**CITY OF TEMPE
DEVELOPMENT REVIEW COMMISSION**

**Meeting Date: 06/10/2014
Agenda Item: 5**

ACTION: Request for an amendment to the conditions of approval for the Development Plan Review for CLARENDON TOWNHOMES, located at 425 West 6th Street. The applicant is Manjula Vaz, Gammage & Burnham PLC.

RE: Clarendon Townhomes (PL130215)
DPR13220 – Landscape Modification – Approval Condition Removal Request

**Conceptual ATTACHMENT 6
 Landscape Plan**

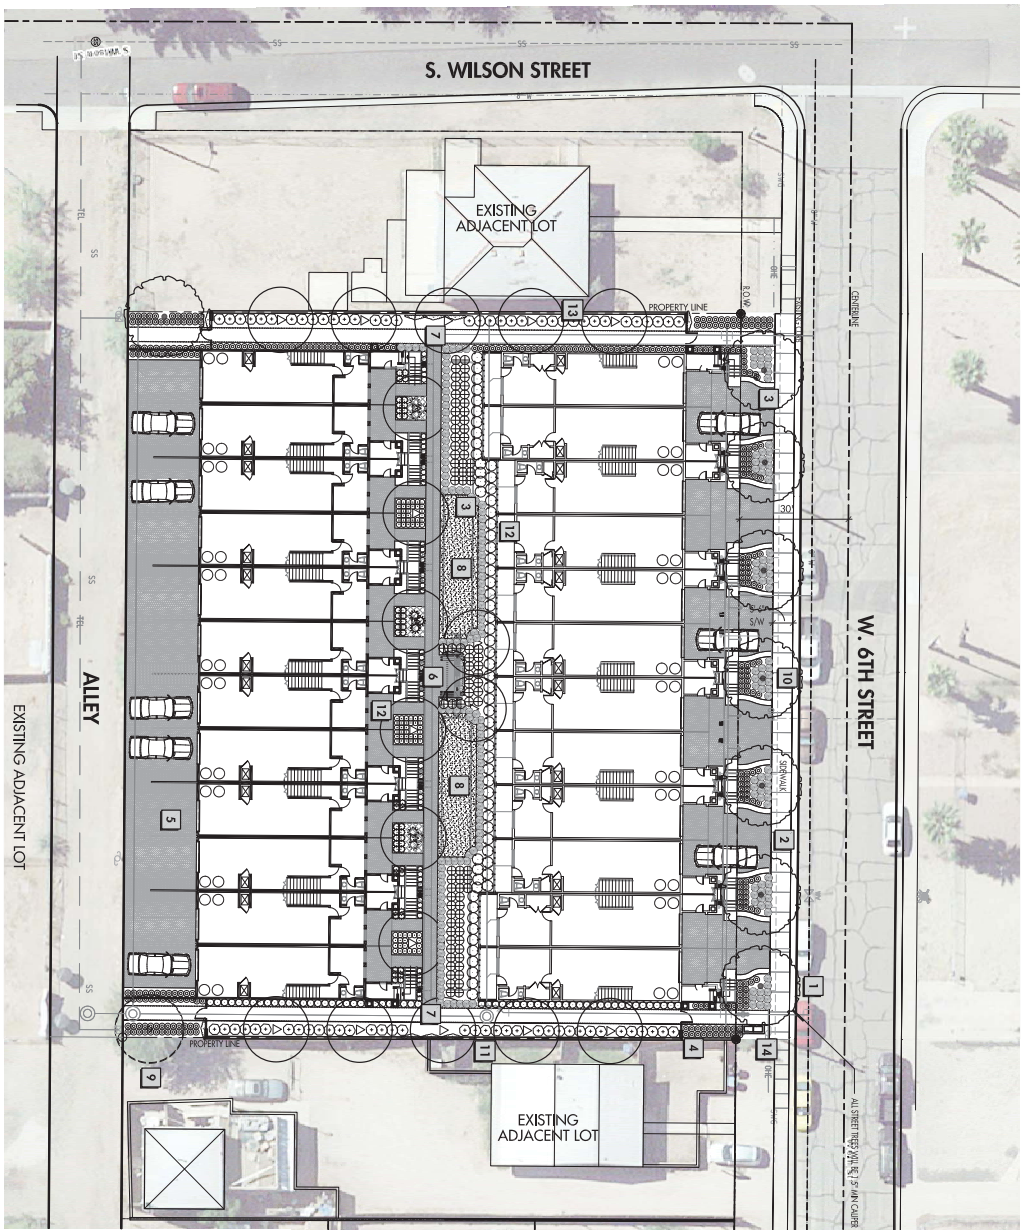
Pursuant to condition number 30, the DPR Approval requires the provision of patio landscape trees within planters or tree grates at the end of the Project’s drive aisles adjoining the alley to the south of the Site for the purposes of providing shade and providing a buffer for the properties located south of the alley.

As reflected by the enclosed landscape plan approved by the DRC, approximately 25 percent of the Site will be landscaped area, a significant and generous amount for any development within an urban setting. As noted in the staff report for the referenced DPR application, the Project’s landscape is lushly planted to maximize shade and to provide a green appearance. The Project will provide resort like landscaping for the purposes of 1) providing shade and a pedestrian friendly environment along the streetscape, 2) providing a comfortable and inviting outdoor experience for residents and guests within the Project’s interior courtyards, and 3) enhancing the quality of the Project’s outdoor experience between the building and Sixth Street.

In contrast to the Project's landscape plan, the provision of trees along an alley within an urban setting is atypical, impractical and problematic. For an urban development like the Project where vehicular access occurs from a public alley, the provision of trees, including trees provided within grates or planters, will create unnecessary vehicular maneuvering conflicts for both residents and the City's Public Works staff. As a result, reoccurring damage to trees, planters and/or vehicles is likely. In addition, any trees provided along the alley will be shaded by the Project's patios located on the second level. As a result, these trees are likely to become unhealthy, unattractive and require continuous and burdensome replacing by future residents.

As mentioned above, the stated purpose of condition number 30 is to provide shade and to provide a buffer from properties located south of the alley adjoining the Site. As discussed above, the end of the drive aisles where the trees in question are to be provided will be shaded by the Project's patios located on the second level. Therefore, providing trees at the end of the drive aisles along the alley will not result in the provision of any additional shade of significance. In regard to providing a buffer from the properties located across the alley to the south, the Project's residences, with the exception of the covered carports on the first level and the patios on the second level, will be setback 20 feet from the Site's south property line. When combined with the adjoining alley to the south, the Project's enclosed living spaces and patios will respectively be setback 40 and 28 feet from the adjoining properties across the alley. The noted setbacks will ensure that an appropriate buffer is provided, especially for a single-family attached residential development within an urban setting like downtown Tempe.

Therefore, pursuant to Section 6-312(C)(4) of the ZDC, we respectfully request that the DRC remove approval condition number 30 from the DPR approval.

Based on the above analysis, staff recommends denial of the requested removal of condition #30 of the Development Plan Review.

The PAD overlay process was specifically created to allow for creative design solutions with greater flexibility. Entitlements were received based on the proposed plans as presented, without full resolution of the balcony details on the south side but with the agreement to the conditions of approval at the public hearing.

A-202

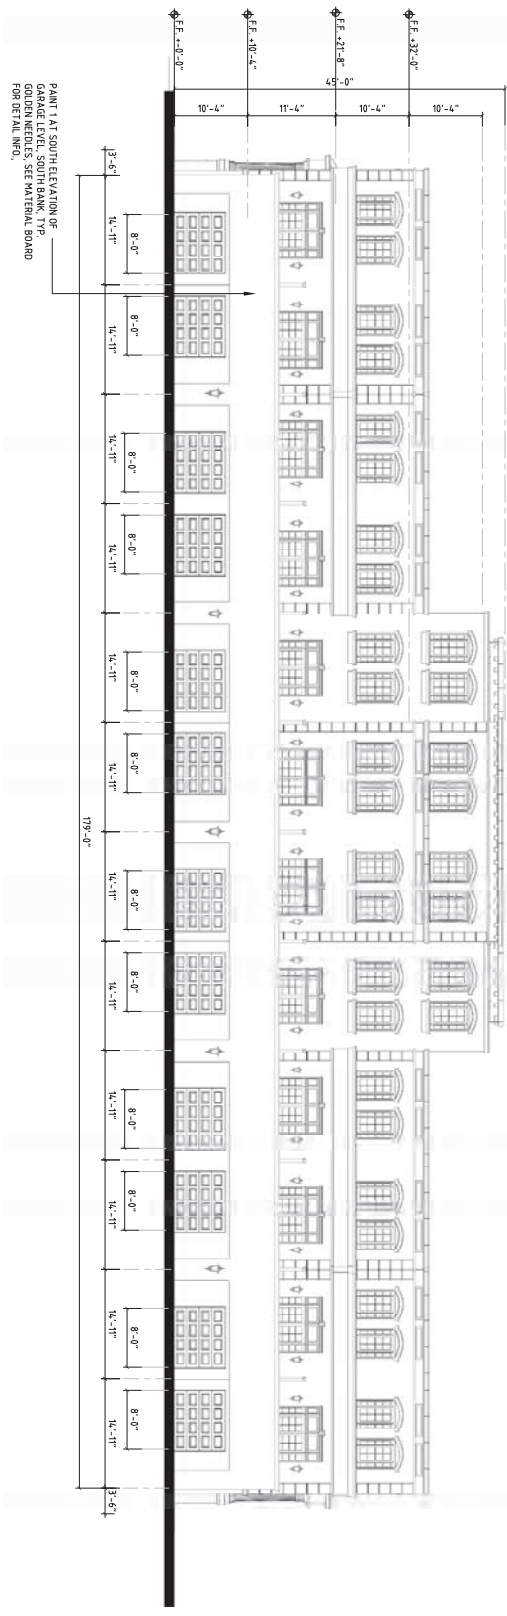
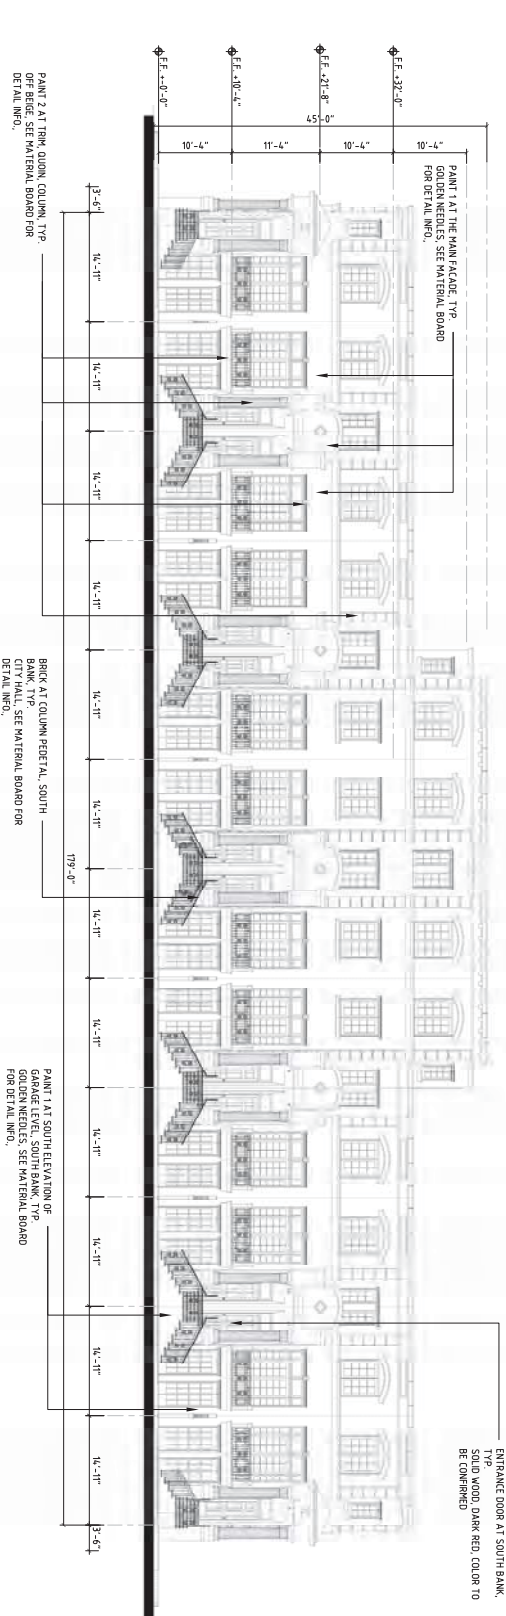
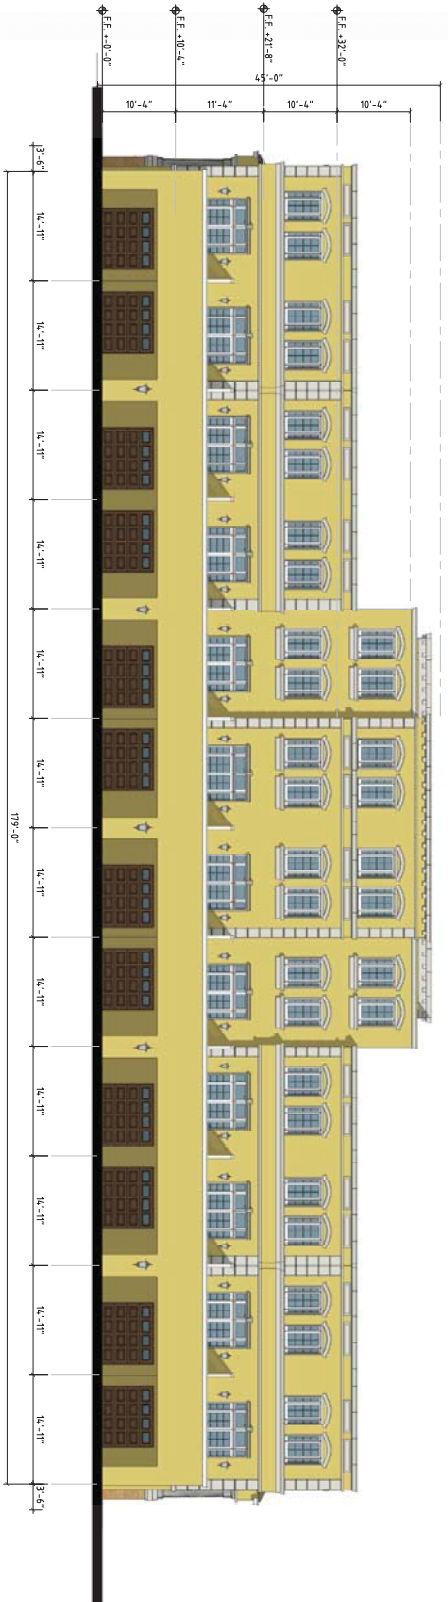
As part of the original request for a Planned Area Development and Development Plan Review, increases in height and density were approved subject to the proposed plans. At the time of the hearing, the south side balcony design had not been resolved, due to building safety and fire issues. Without having a specific design for the balconies finalized, staff included Condition #30 to soften the building massing and provide a visual landscape buffer to the residences to the south, and to provide shade to the south side of the units. This minimal landscape requirement could be designed either with potted patio trees or in ground tree grates, to mitigate the heat impacts on the southern side of the site. Below are images of the intent of Condition #30:

These trees would not be in the alley, but set back on property, between driveways, in front of the balconies which partially overhang the tandem drives. The depth of the south driveways are 20' from face of garage to alley right of way, the balconies extend 12' from the face of the units, south over the driveways. The 8' depth of drive is an entirely paved surface, the entire length of the building, with no landscape. This is the area conditioned to have either tree grates or pots, to the south of the balconies, not shaded by the balcony. This condition was reviewed by Public Works refuse, water and engineering staff as well as Fire staff; it was determined to not be in conflict with access and maneuvering requirements for their services to the site. Through the original design request, the applicant reduced the standard backing distance from 23' to 22', (20' alley depth, 2' on site in the drive, 18' tandem parking space in the drive). The applicant demonstrated through drawings provided to staff that there would be sufficient maneuvering room for vehicles parked in the drives to exit the property in this urban configuration. There does not appear to be a conflict with the circulation for the units. Within a landscape strip approximately 6' wide by 8' long, with a tree grate or a raised planter, smaller patio trees could be sustained.
